IN THE MATTER OF An application RM24.184 by Oceana Gold (New Zealand)
Limited for various consents relating to the Macraes Phase Four
mine expansion

**STATEMENT OF EVIDENCE OF
ALEXANDRA MACDONALD BADENHOP
ON BEHALF OF OTAGO REGIONAL COUNCIL**

30 May 2025

Attachment A: Comparison of DC08 monitoring location with modelled location

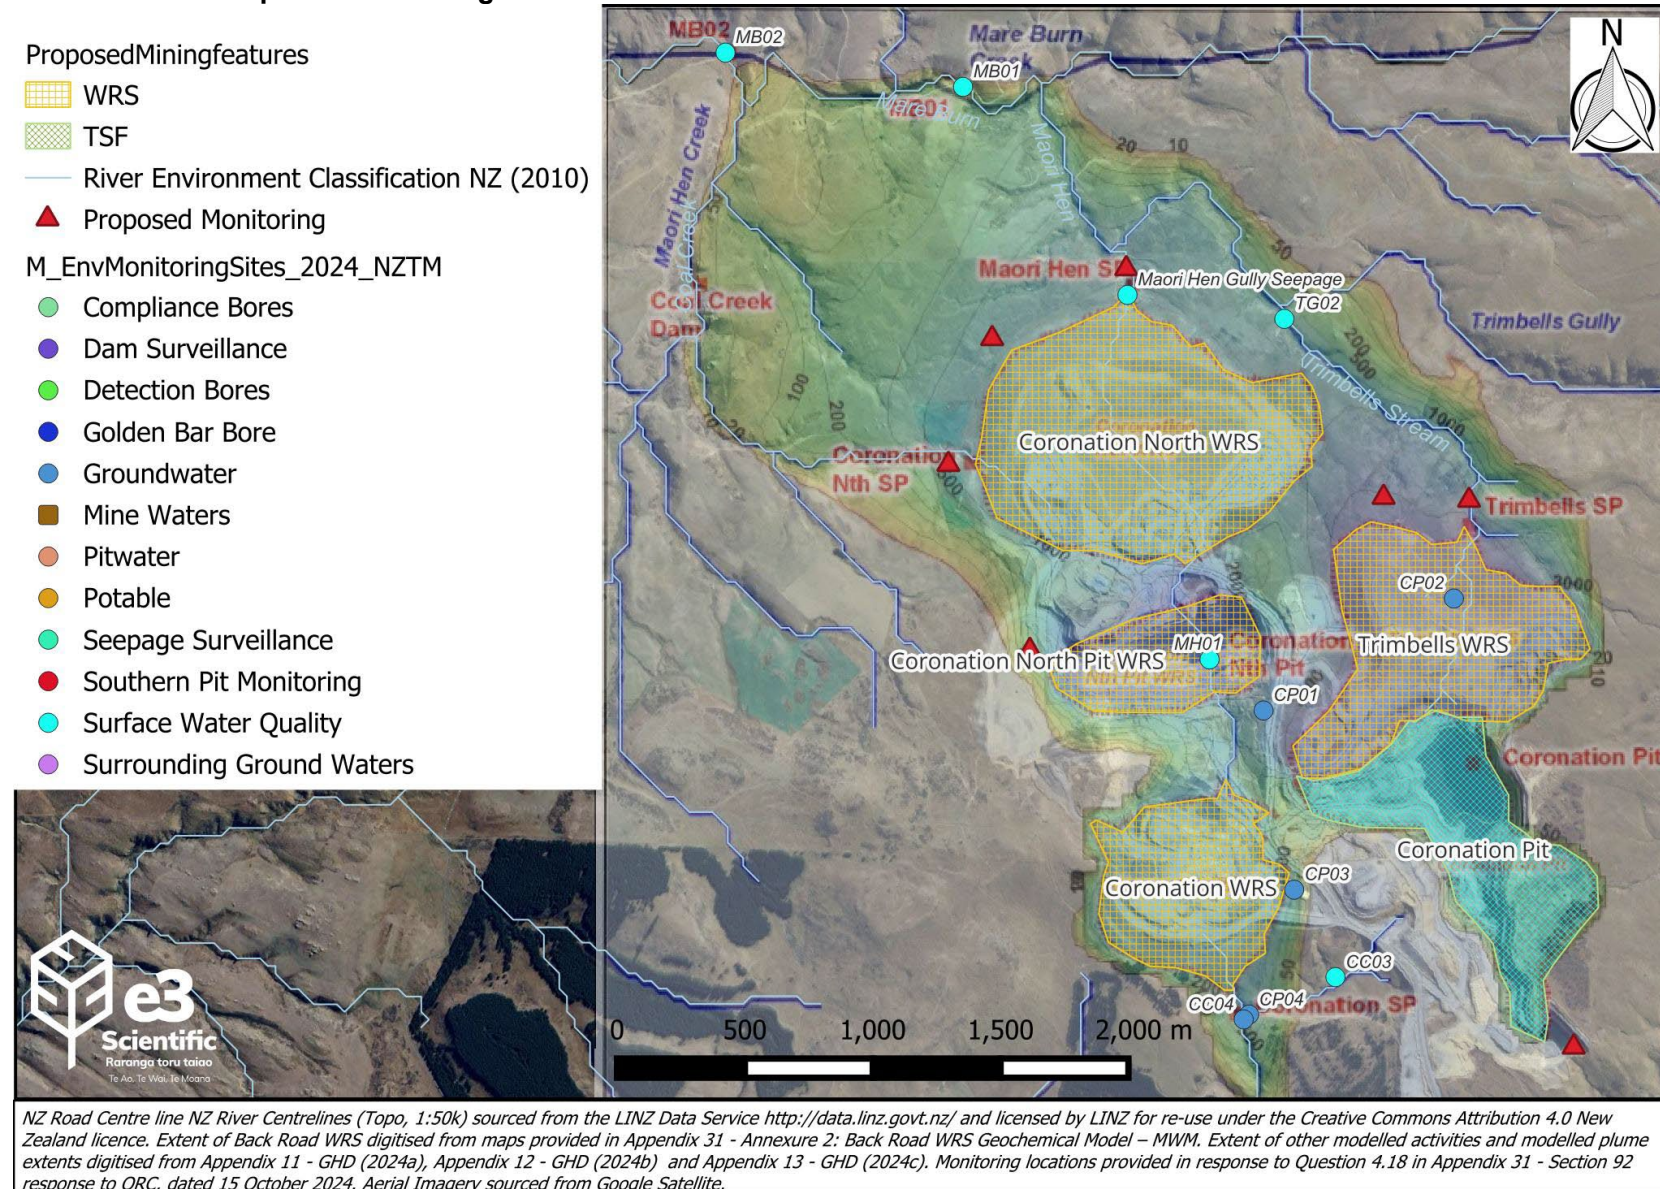
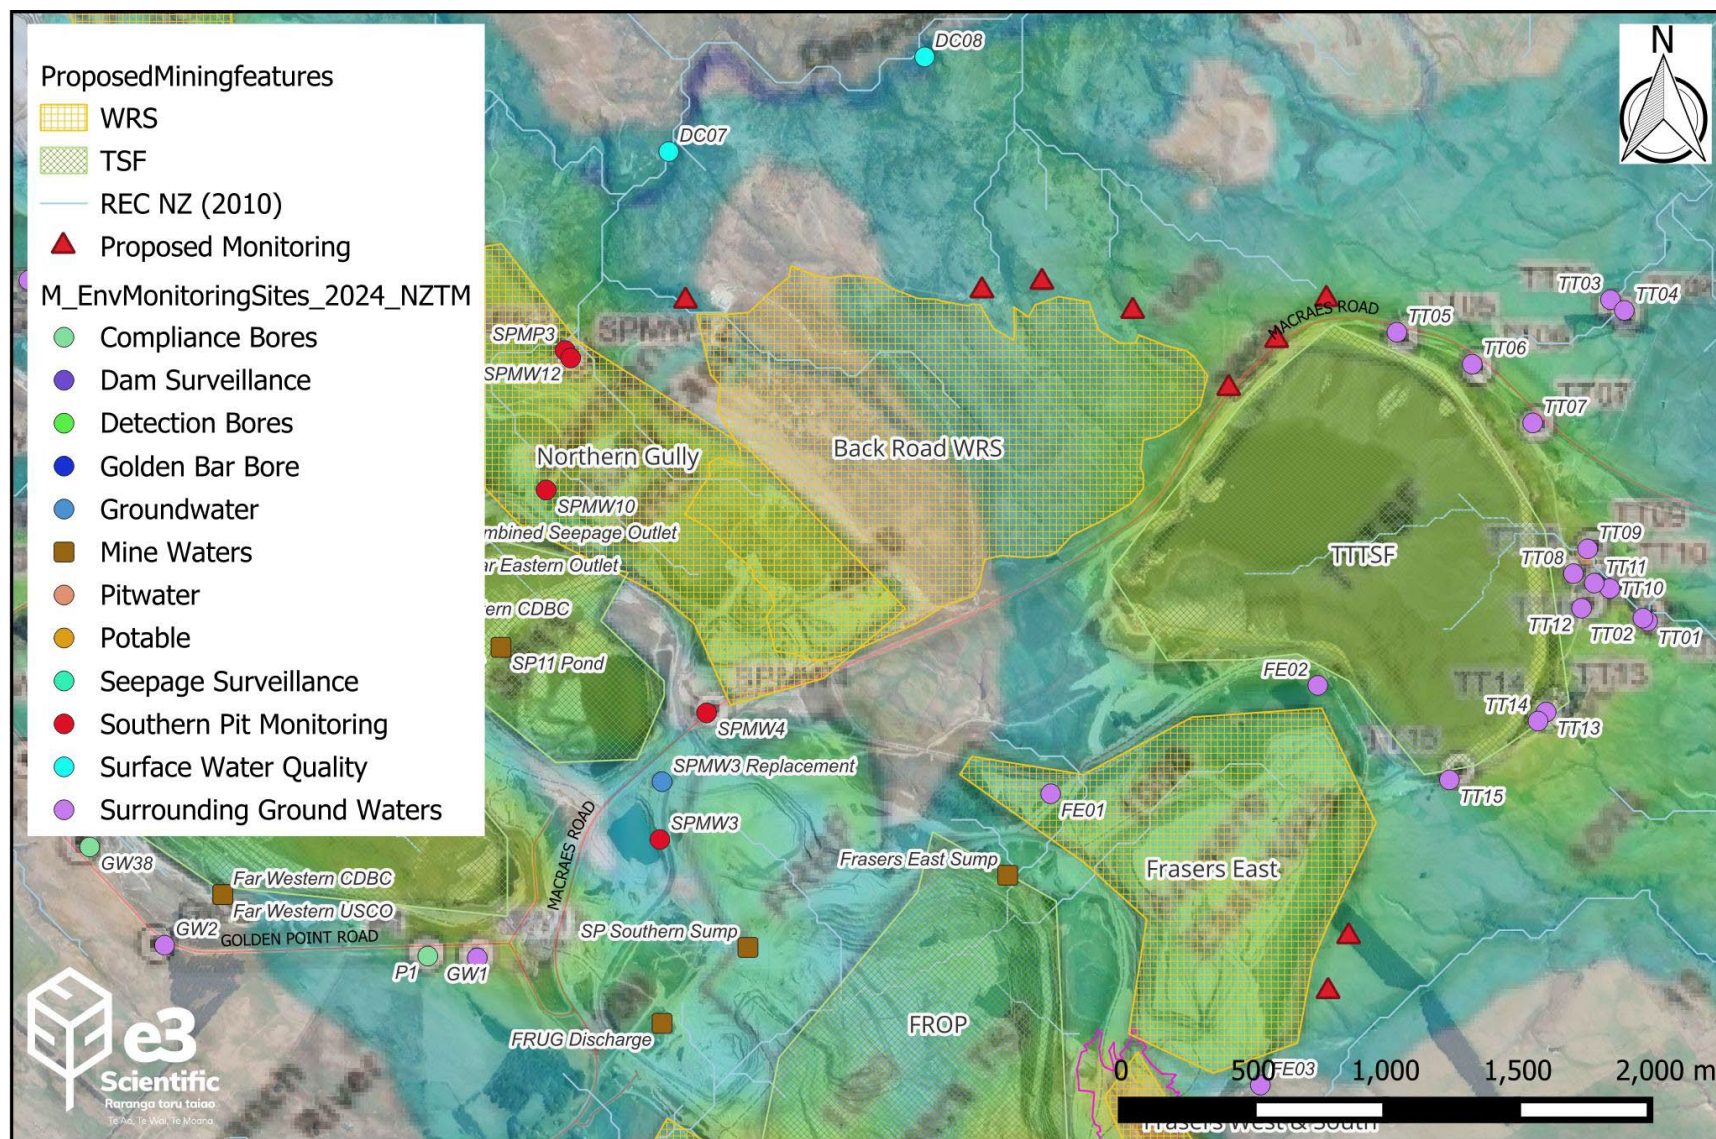
- 8.10 Sulphides have not previously been monitored but could be problematic in anoxic groundwaters.
- 8.11 The location of DC08 used in the modelling assessment appears to be different to the current compliance monitoring location, as provided in response to Question 4.18 in Appendix 31 - Section 92 response to ORC, dated 15 October 2024. This will affect the catchment area that reports to the WBM model node (see Figure A5 of Appendix 13 - GHD (2024c), and also indicates that some of the mining activities e.g. BRWRS, may impact Deepdell Creek downstream of the DC08 compliance point. A comparison of the locations is provided in Attachment A.

Attachment B: Proposed Monitoring Locations

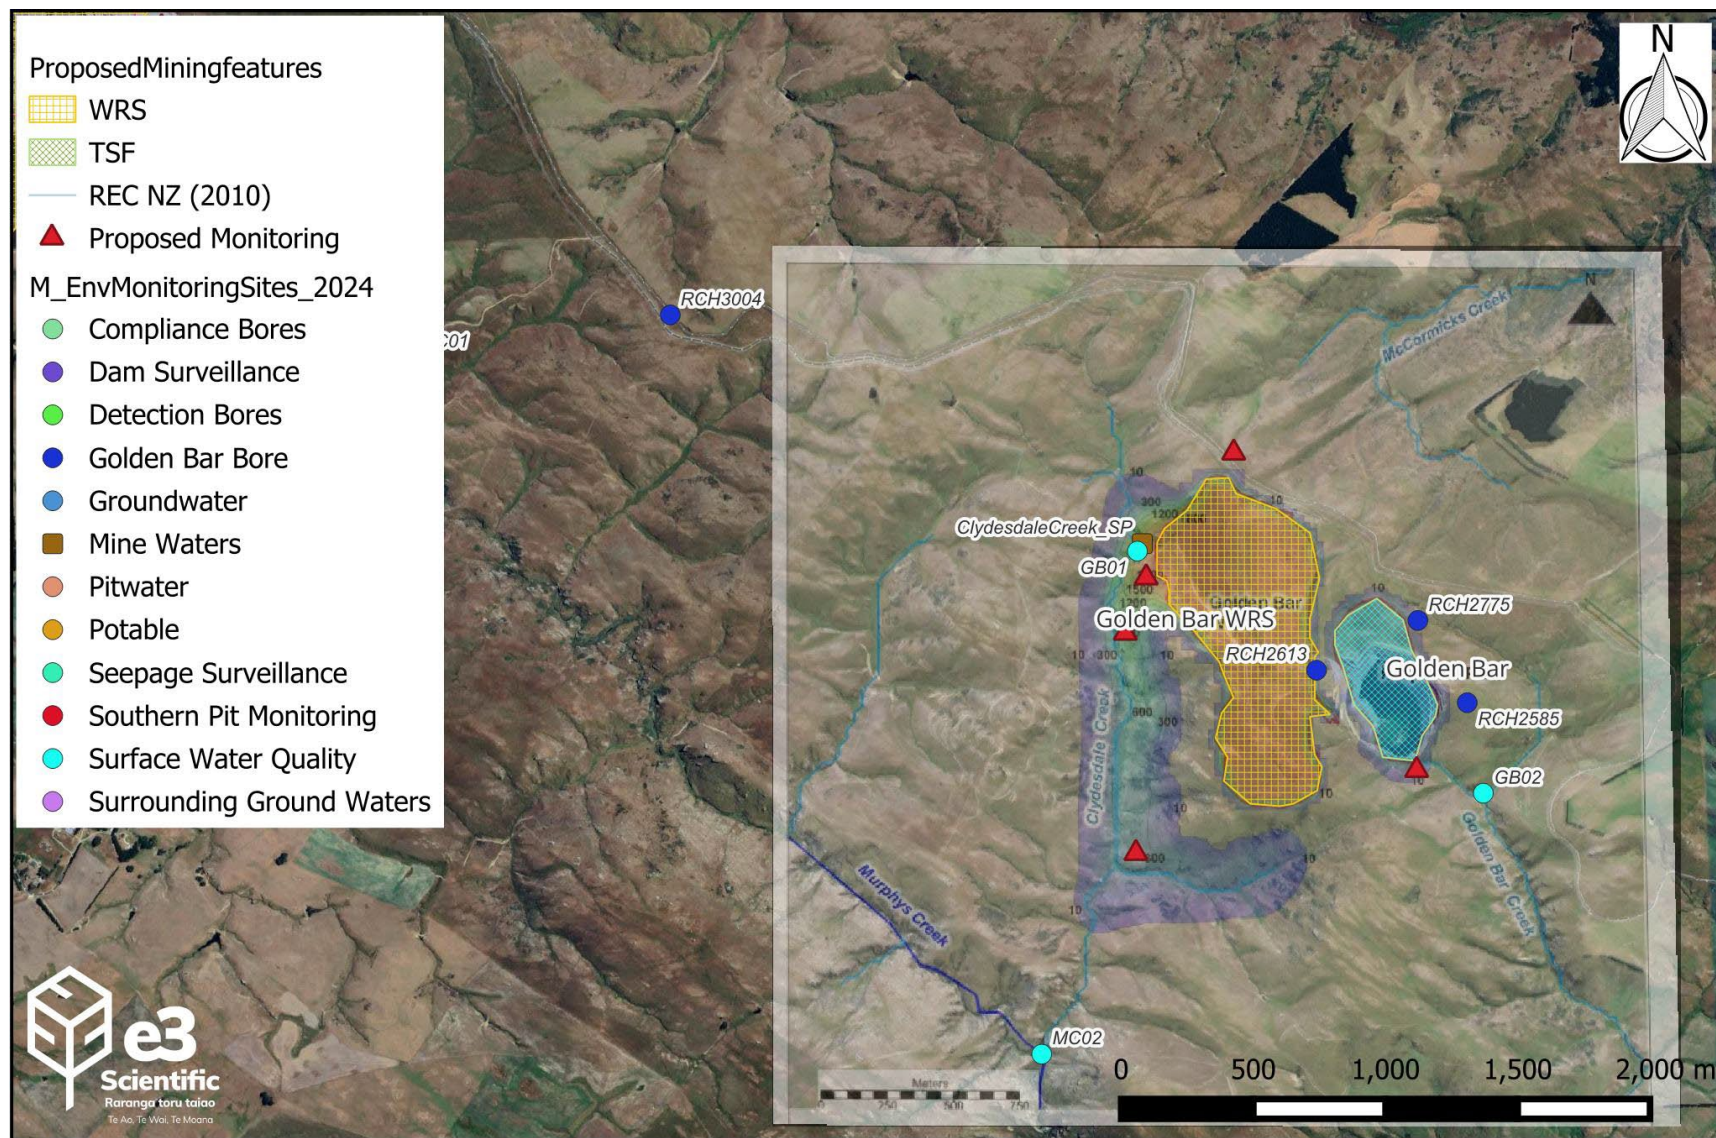
12.9 Given the anticipated slow travel time within groundwater, new monitoring bores should be installed within 25 m of waste rock stack toes or the distance the plume is expected to travel within 10 years. Suggested locations for proposed monitoring bores are provided in Attachment B.
